Contract #: 04-0120F4Cty: SF/ALA Rte: 80 PM: 13.2/13.9File #: 69.25B**QUALITY ASSURANCE -- NON-CONFORMANCE REPORT****Location:** Changxing Island, Shanghai, P.R. China**Report No:** NCR-000504**Prime Contractor:** American Bridge/Fluor Enterprises, a JV**Date:** 12-Nov-2009**Submitting Contractor:** Zhenhua Port Machinery Company, Ltd (ZPMC), Changxing Island**NCR #:** ZPMC-0477**Type of problem:**

Reference Description: Corner Assembly components X37 for Lift 9W were damaged due to improper handling and storage.

Job Name: SAS Superstructure

Subject: NCR No. ZPMC-0477

Heat Straightening Record(HSR1)

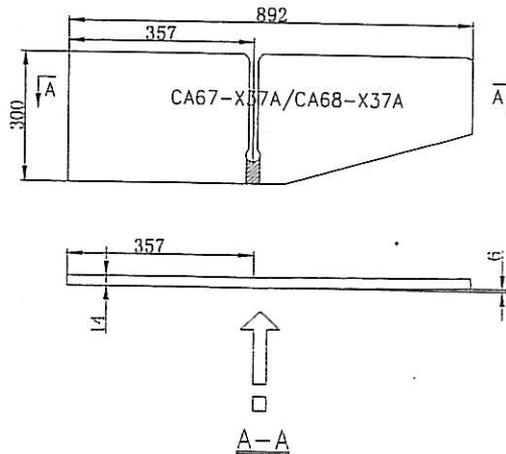
| Cause 原因 | Welding distortion 焊接变形 |

缺陷去除方法(Defect Removal Method): Flame Straightening by oxygen acetylene 运用氧乙炔进行校火

注: 最大变形量约6mm, 校火宽度20~50mm.

NOTE: the max deformation is about 6mm, heat straightening the width is 20~50mm.

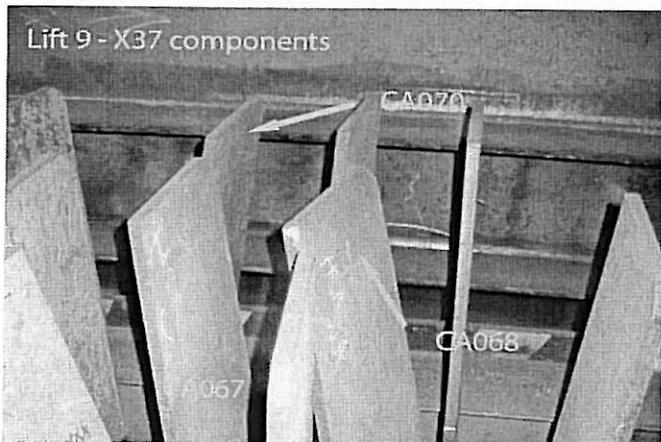
During in-process visual inspection of the fabrication of X37 for Lift 9 West, Caltrans Quality Assurance Inspector observed that Corner Assembly components CA067, CA068, and CA070 identified as X37 were damaged. The storage and handling of these X37 components are not according to the requirement as indicated in the Standard Specifications.

Caltrans Standard Specifications, July 1999, Section 55-1.04: In handling of the steel work, every care shall be taken to avoid bending, scraping or overstressing the pieces. All pieces bent or otherwise injured will be rejected.

Caltrans Standard Specifications, July 1999, Section 55-3.09: Finished members shall be true to line and free from twists, bends and open joints.
